PX3 OWNER'S MANUAL ERRATA

Rev. A8-1, February 15, 2017

E740229E

2. **Page 28 under *Mass Storage Support:***

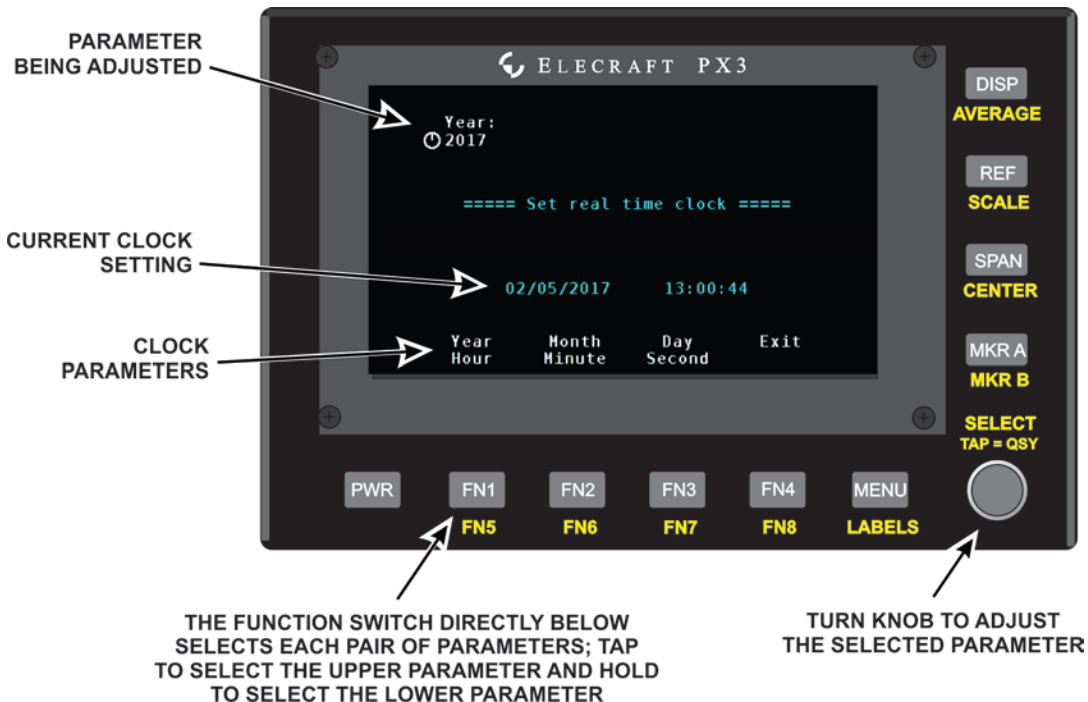
The date and time added to files stored on the MSD are determined by a clock in the PX3. Set the clock as follows:

- **MENU:** ⌚ *MSD menu*
- Tap the ⌚ **SELECT** knob to enter the MSD Menu and then turn it to select *Set Clock*.
- Tap the ⌚ **SELECT** knob and enter the current date and time as shown below:

⚠ There is no battery backup for the clock. It stops whenever the PX3 power is turned off.
